Addendum 2 – Regulation No. 3

Revision 4 - Amendment 2

Supplement 16 to the 02 series of amendments – Date of entry into force: 8 October 2015

Uniform provisions concerning the approval of retro-reflecting devices for power-driven vehicles and their trailers

"Figure 1
Marking for single lamps

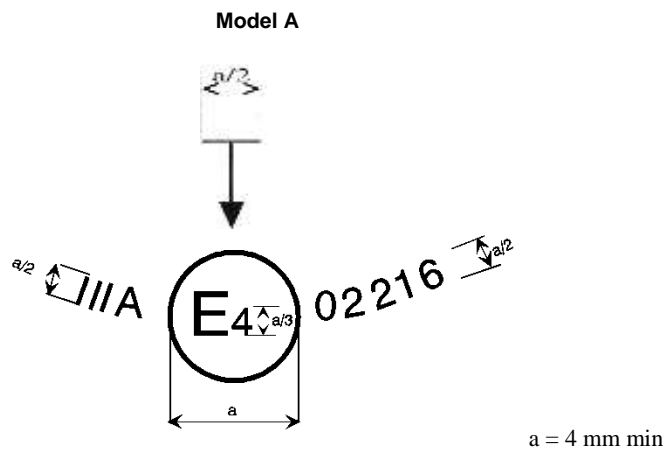
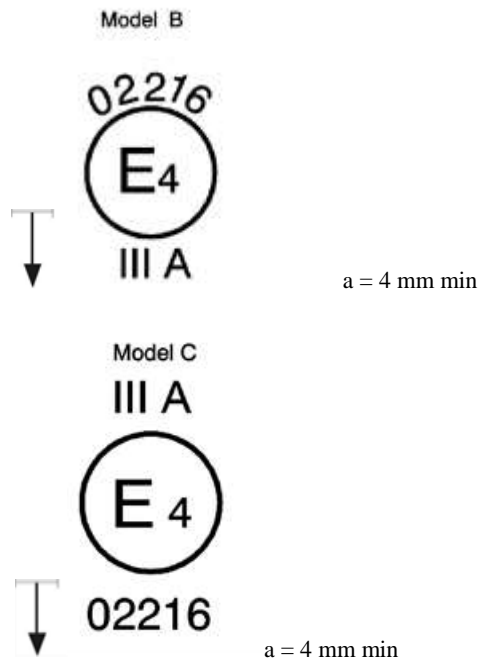
Figure 1., amend to read:

The above approval number shall be placed close to, but in any position in relation to, the circle surrounding the letter "E". The digits constituting the approval number shall face the same way as the "E". The group of symbols indicating the class shall be diametrically opposite the approval number.

The vertical arrow starting from a horizontal segment and directed downwards indicates a permissible mounting height of equal to or less than 750 mm from the ground for this device and can be placed either above or below the circle surrounding the letter "E" or at its side, close to the group of symbols indicating the class or the digits constituting the approval number.

The above approval mark affixed to a retro-reflecting device shows that the type of device concerned has been approved in the Netherlands (E4) under approval number 02216. The approval number shows that approval was granted in accordance with the requirements of the Regulation as modified by the 02 series of amendments."
